Explanation of Significant Difference for the Revision 1 Record of Decision Remedial Alternative Selection for the Wetland Area at Dunbarton Bay in Support of Steel Creek Integrator Operable Unit (U)

SRNS-RP-2022-00982

Revision 0

January 2023

Figure 2. WADB Project Area (Showing Previous Land Use Control Boundary)

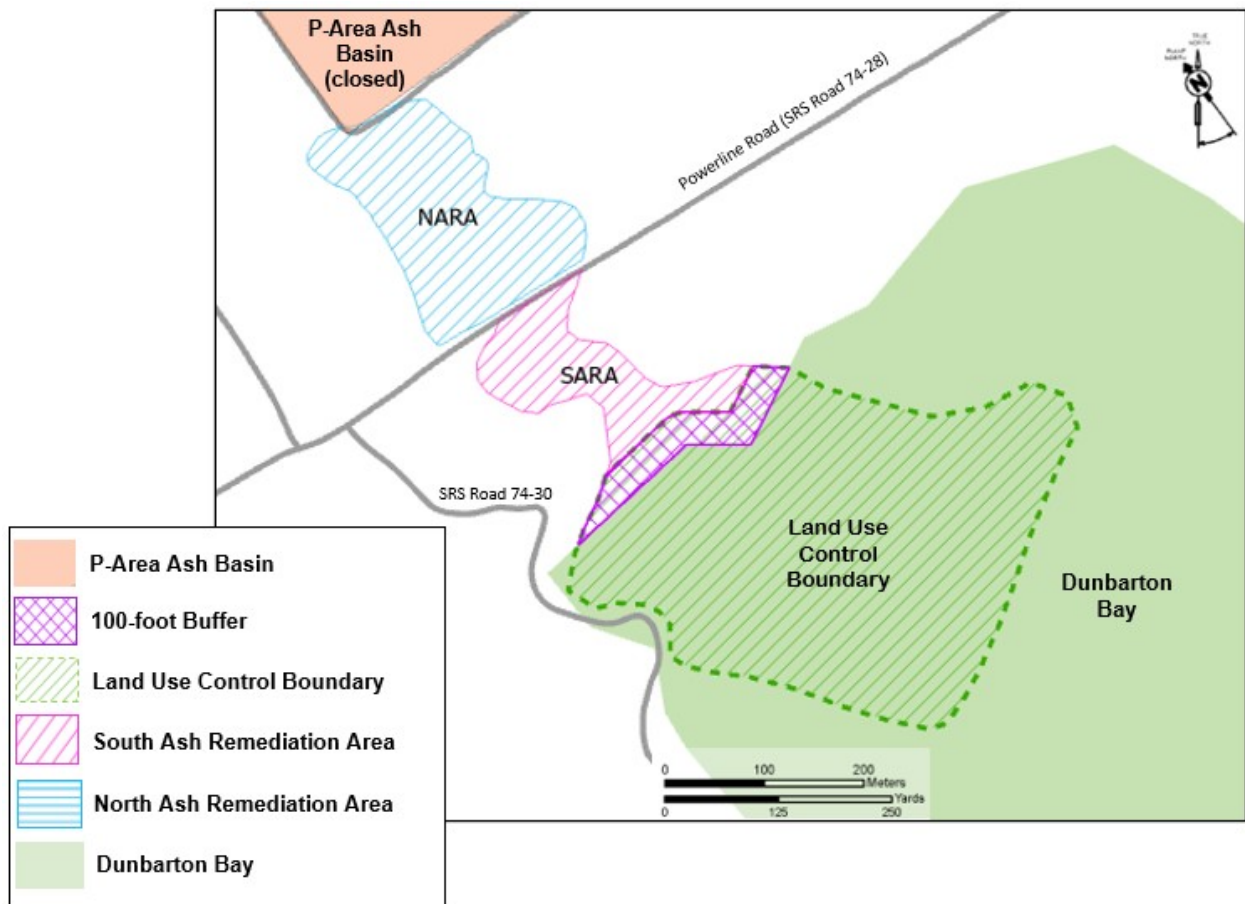
The ROD for the WADB (SRNS 2018a) employed LUCs for 10 ha (25 ac) since the entire volume of waste was not to be excavated and some material would be left in place. The initial LUC boundary is shown in Figure 2. The purpose of this ESD is to document expanded LUCs that include the SARA, the additional ash discovered outside of the SARA, as well as the initial LUC boundary protective of and within the Dunbarton Bay.

Figure 3. Location of Additional Ash, Existing Sign Locations, and Existing Land Use Control Boundary

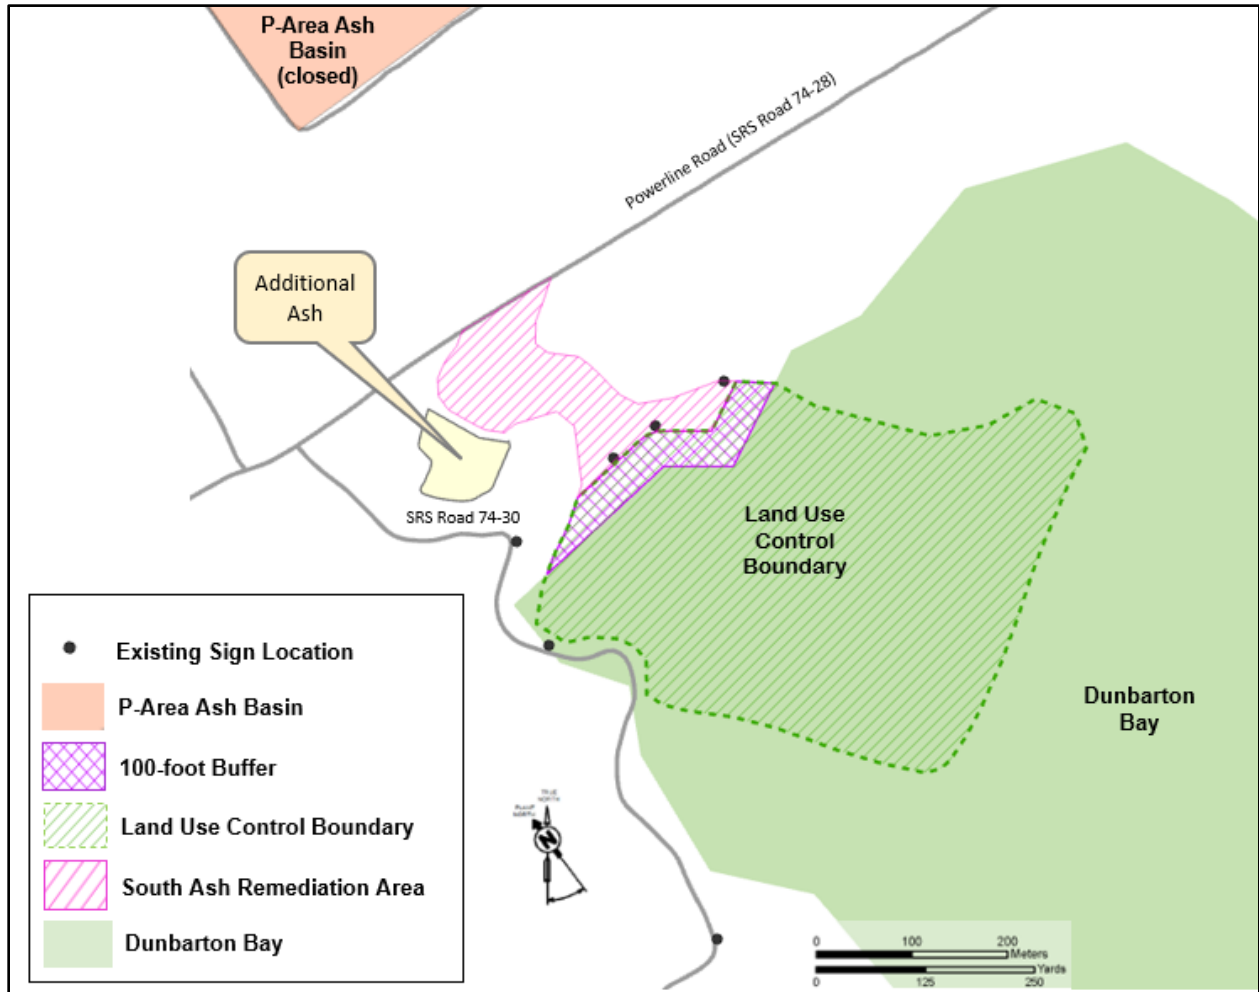
The ROD for the WADB was issued June 20, 2018 (SRNS 2018a). The significant difference described in this ESD is to expand the LUC boundary to include the SARA and additional ash to the east of the SARA in lieu of excavating and disposing of the ash. The additional ash is located between Powerline Road and Dunbarton Bay (Figure 3).

maintains the previously designated LUC area within the 30-m (100-ft) buffer and within Dunbarton Bay (Figure 3). The entirety of the expanded LUC boundary consists of ~16 ha (~39 ac) (Figure 4). The expanded LUCs are estimated to cost approximately \$50,000. It is estimated that pursuing continued excavation and offsite disposal of the SARA and additional ash would cost approximately \$5.8 Million.
